Southern Nuclear Operating Company
Vogtle Early Site Permit Application
Supplemental Response to Requests for Additional Information on Geology/Seismology

Supplemental Response to Geology/Seismology RAIs

Vogtle ESP Application

Figure 1g. Quadratic fit to the amplification values for 0.5 Hz.

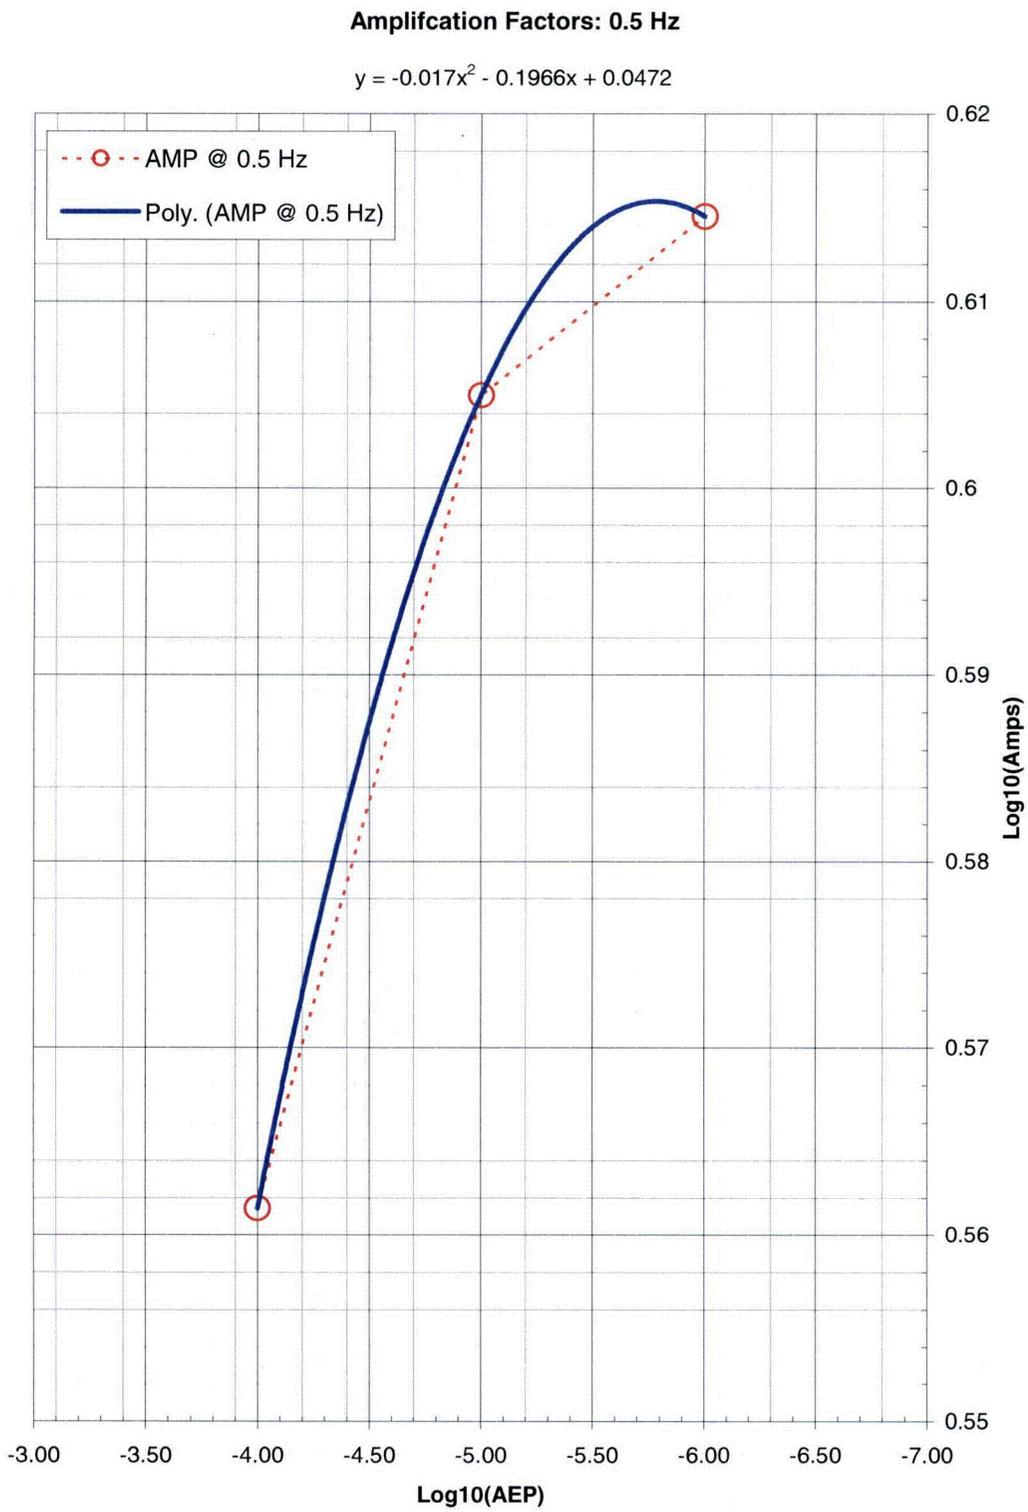
2.5.2-3 In response to this RAI, soil hazard curves were provided at three annual exceedence frequencies (10^{-4} , 10^{-5} , and 10^{-6}). However, in order for the staff to verify the adequacy of the SSE, soil hazard curves are requested at additional annual exceedence frequencies (i.e. at values between 10^{-4} , 10^{-5} , and 10^{-6}).

For each of the seven frequencies a quadratic equation was fit to the log (base10) of the spectral ratios (AMP) as a function of the log (base10) of the annual exceedence probability (AEP). Mathematically, this functional model is given as,

The resulting fits to the three data points are shown in Figure 1, located on the following pages, for each of the seven frequencies. The coefficients and equation are given at the top of each plot. Note that the red dashed line is a linear log-log line between the three data points.

Figure 2.5.2-18A: Seismicity in southeastern US and areas used to examine seismicity effects.

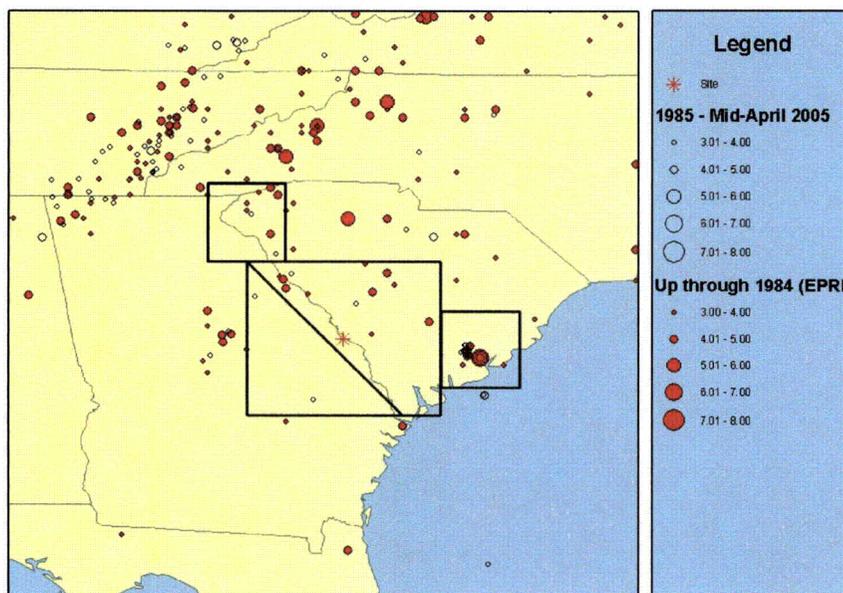
2.5.2-18 Please provide justification for the selection of the geometries shown in SSAR Figure 2.5.2-16 as well as RAI Figure 2.5.2-18A. Specifically, why were these particular geometries selected over other possible geometries? In addition, please justify the exclusion of the recent seismicity associated with the Helena Banks fault zone from all of the selected geometries.

Several areas were used to examine the effect of the new regional earthquake catalog. RAI figure 2.5.2-18A shows these areas. The areas were selected because sensitivity studies showed that seismic sources in the vicinity of the site, in the Charleston, South Carolina region, and in northwestern South Carolina were the main contributors to seismic hazard at the Vogtle site. The large rectangular source surrounding the site spans 2.5° longitude by 2° latitude, the source representing Charleston, South Carolina, spans 1° longitude by 1° latitude, and the source in northwestern South Carolina spans 1° longitude by 1° latitude. These sources were selected as representative of the regions important to seismic hazard analysis. In addition, the large source surrounding the site was divided with a diagonal line to capture seismicity in the northeast half of the source, so that seismicity would not be combined with the relatively aseismic, southwest half of the source.

SSAR Figure 2.5.2-37 Typical Results of Spectral Amplification at 86-ft Depth (Top of Blue Bluff Marl) Using EPRI Degradation Curves for High Frequency Time Histories of 10^{-4} MAFE Input Motion Level

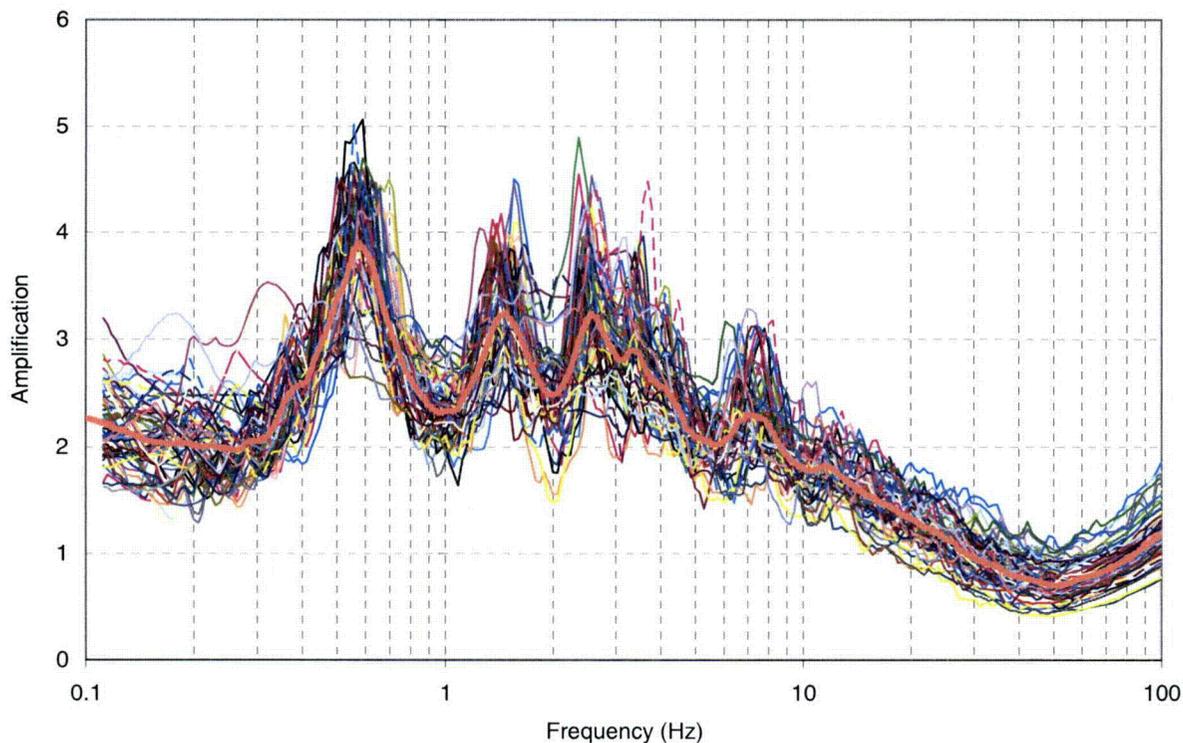
2.5.2-19 Supplement the RAI with additional information related to STEP 5. Please include a definition, and a figure (or table), of the envelope motion. The response to this RAI states

However, it is not clear if the envelope motion refers to the envelope of the mean AFs or envelope of the mean response spectra at the control point.

SSAR Figure 2.5.2-37, repeated below, illustrates the 60 individual AFs and the logarithmic mean AF across the frequency range of 0.1 Hz to 100 Hz, for the 10^{-4} MAFE, HF input, EPRI mean material curves, and 86' depth.

Figure 1. Comparison between the linear average of the suite of 30 spectrum compatible time histories (red line), target spectrum (thick gray line), target spectrum divided by 1.1 (dashed blue line), and target spectrum multiplied by 1.3 (dashed green line) for the high frequency 10^{-4} case.

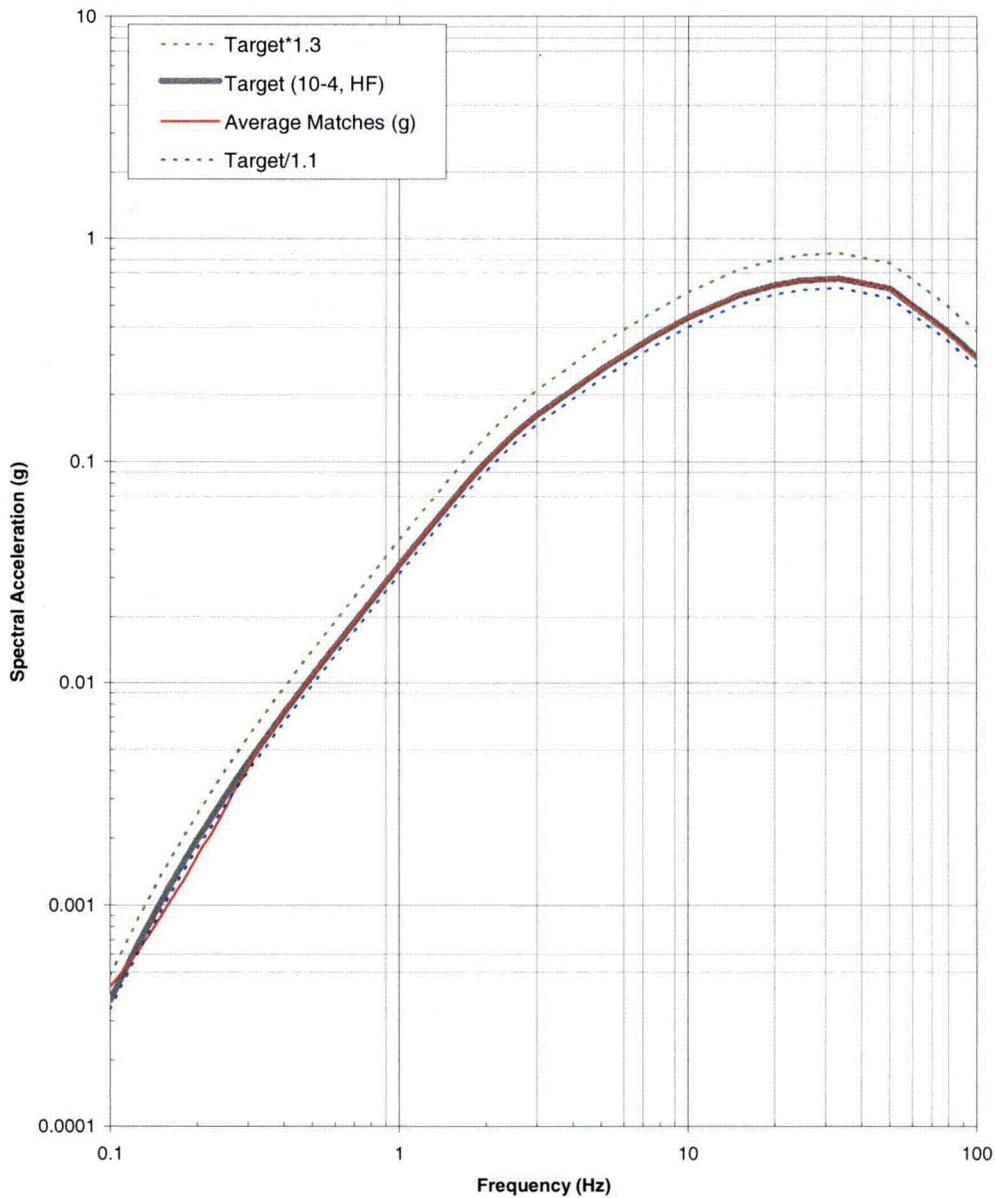
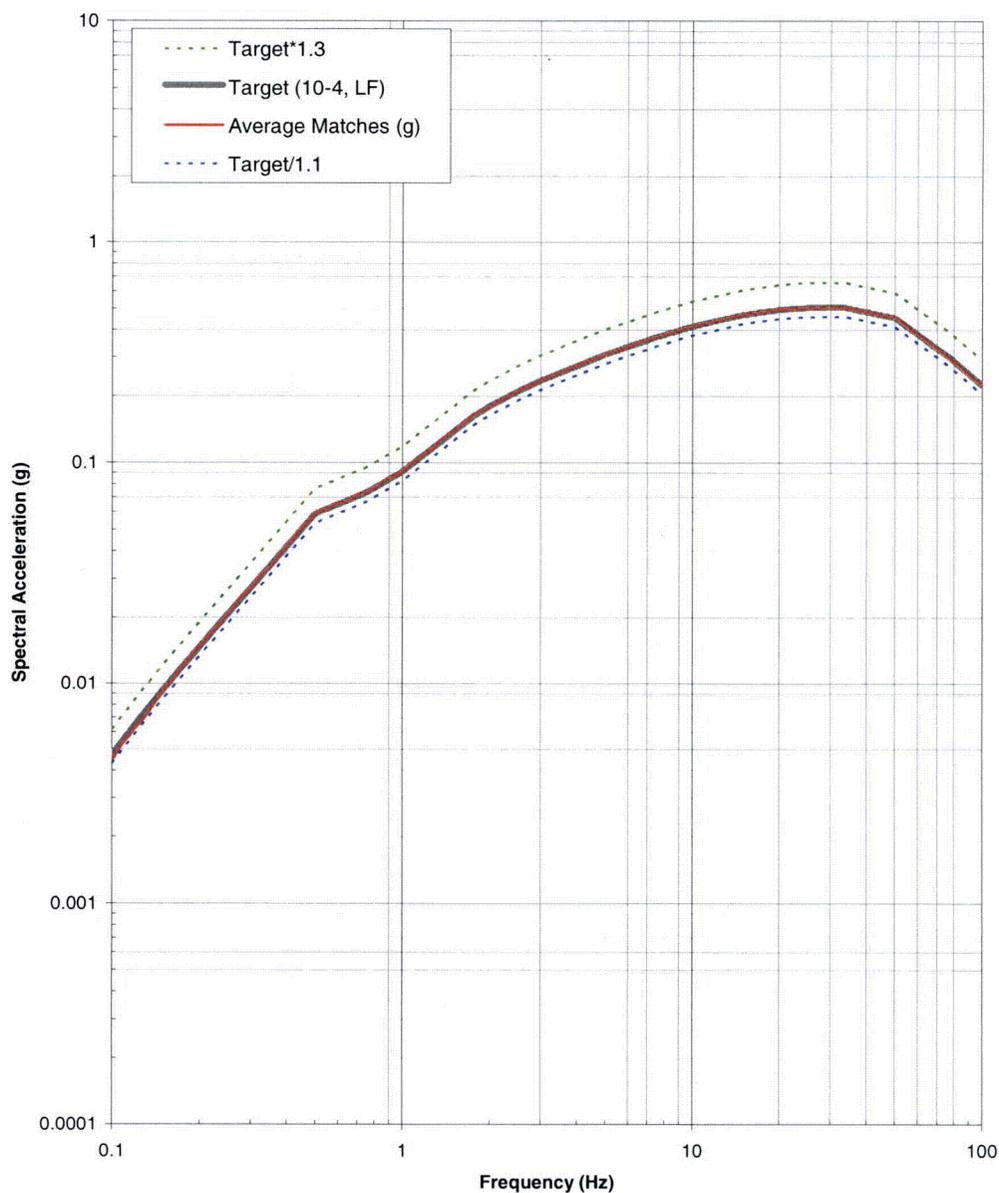
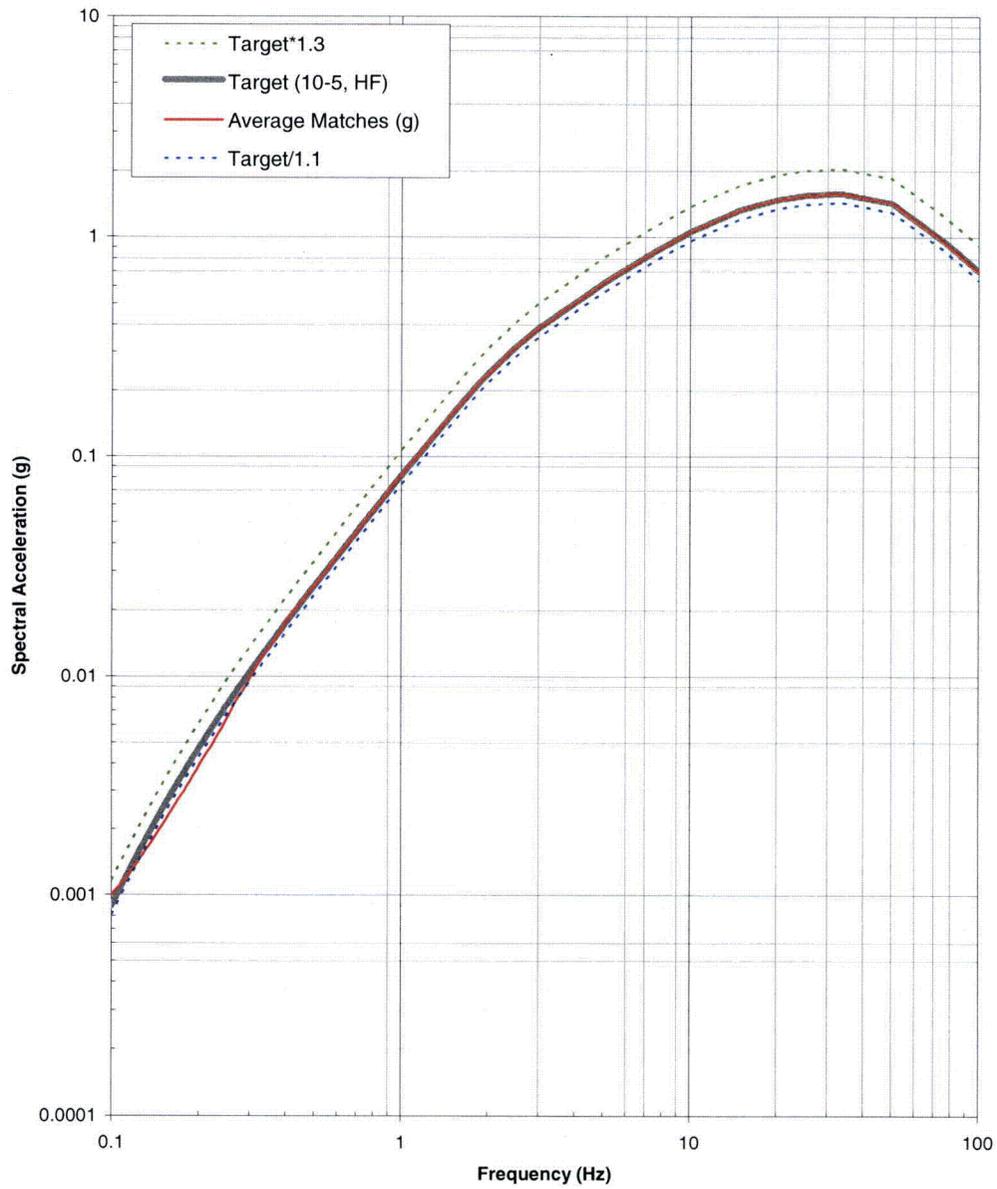
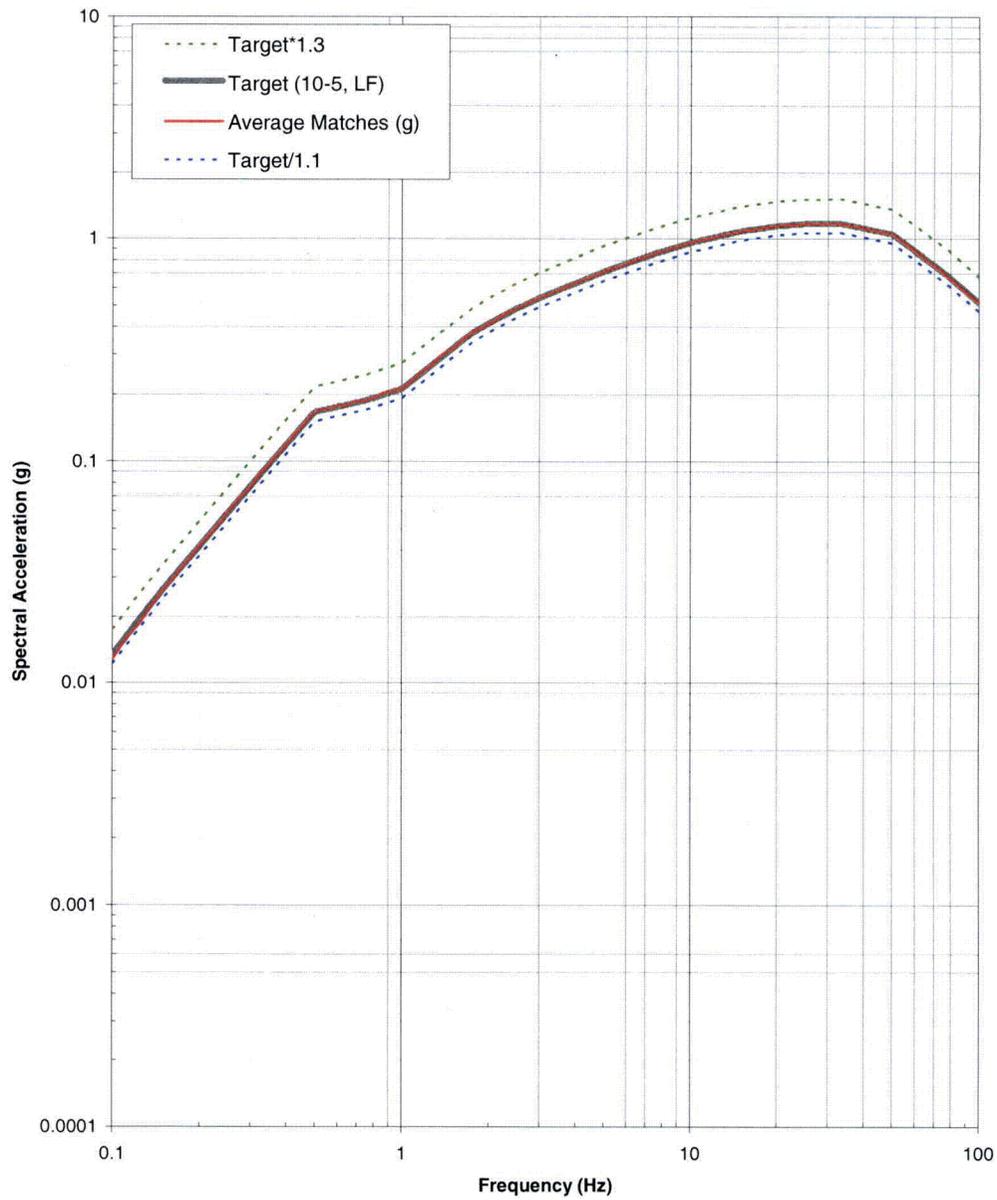
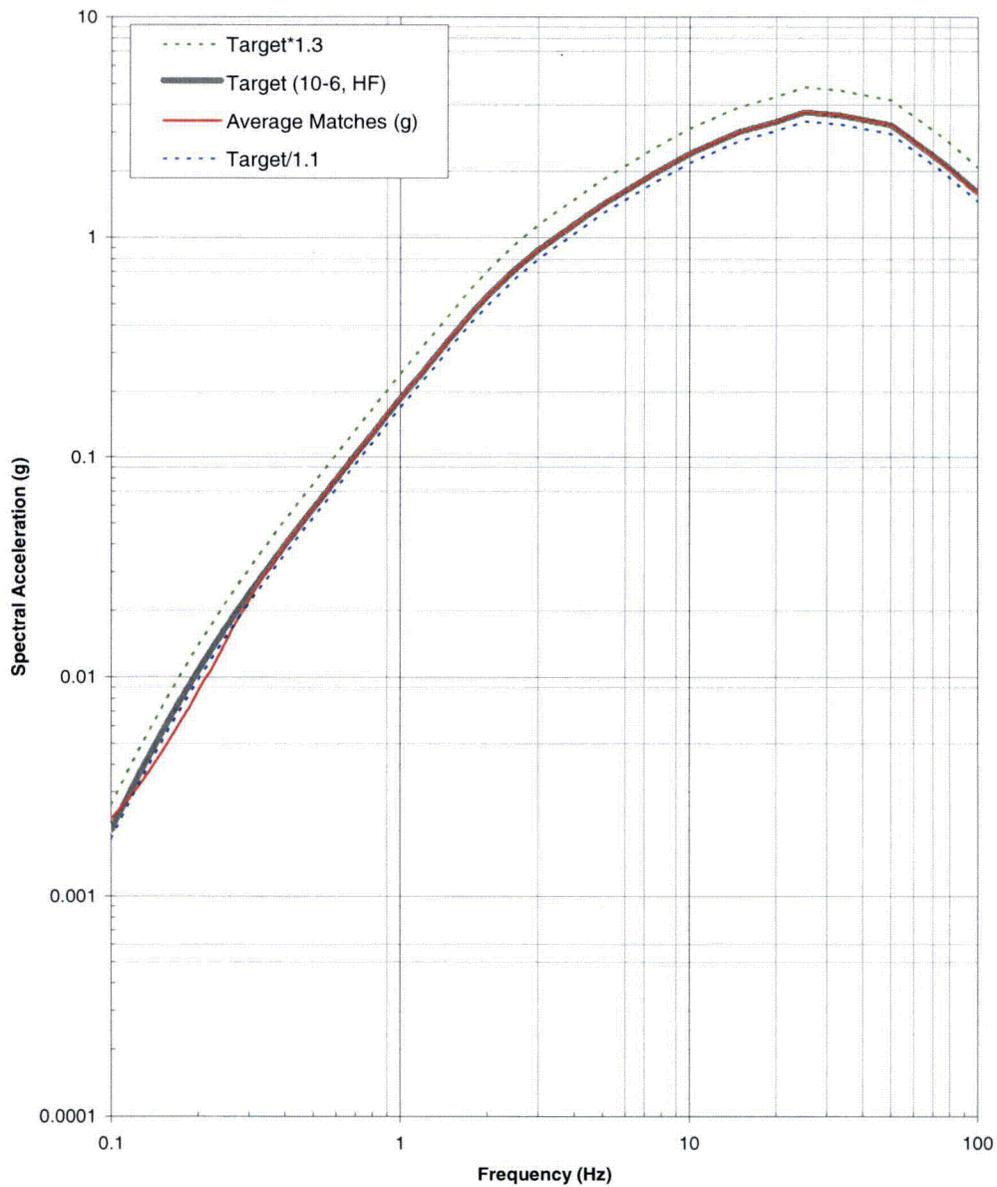
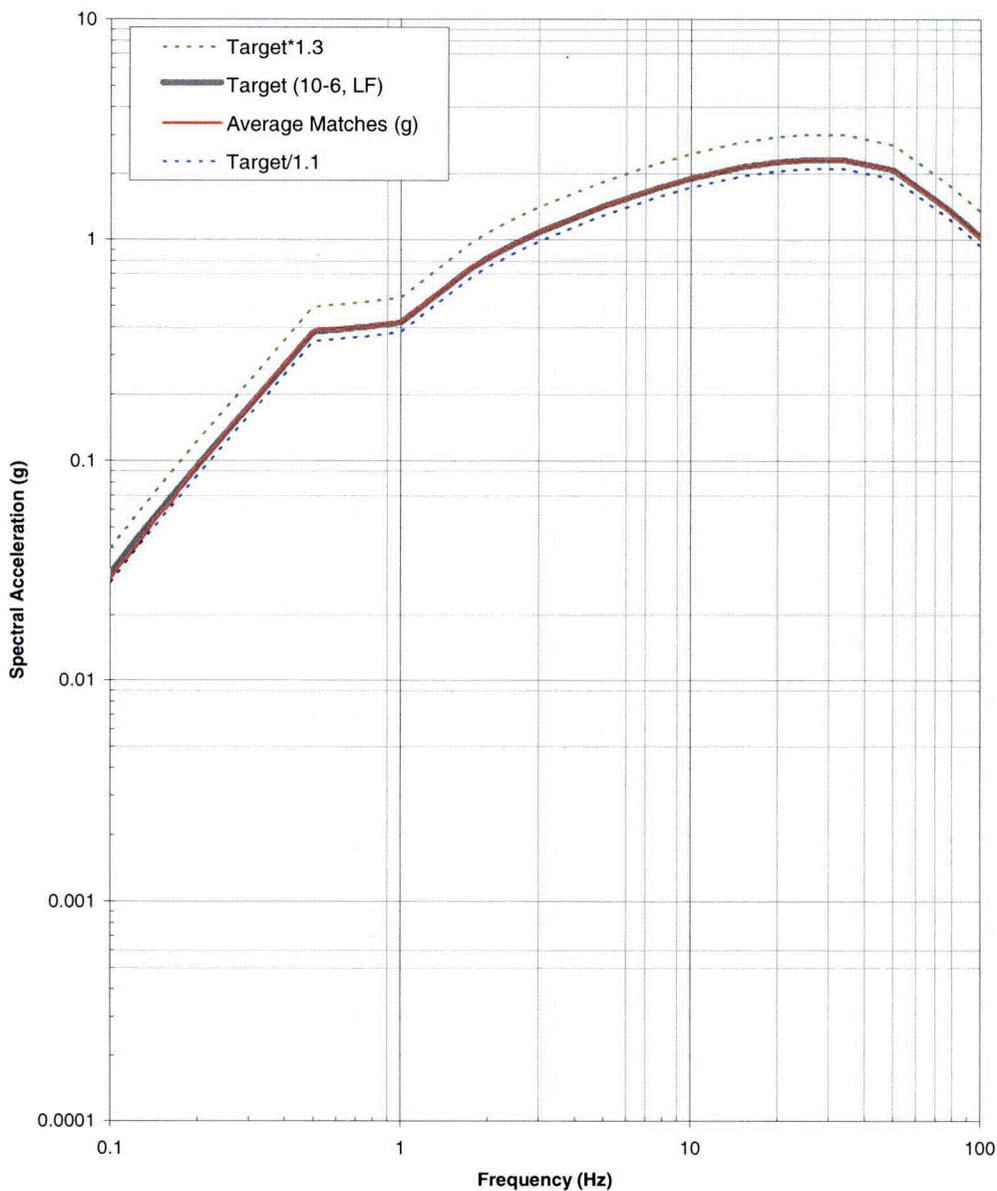
Please explain whether the additional criteria listed in NUREG/CR-6728 were also satisfied. If these additional criteria were not satisfied, please provide justification for not doing so.

As specified in the NUREG CR-6728 spectral matching criteria, when using multiple sets of time histories, the mean (linear average) of the 5% damped response spectra (in this case for a given suite of 30 matches) can be used in place of the individual 5% damped response spectra for checking against the target response spectra. Criteria (a), (d), and (e) define the matching requirements for the mean response spectra and the given target response spectra. These criteria are defined for the frequency range of 0.2 to 25 Hz. For the three low frequency cases (i.e., 10^{-4} , 10^{-5} , and 10^{-6}) the mean of the suite of spectrum
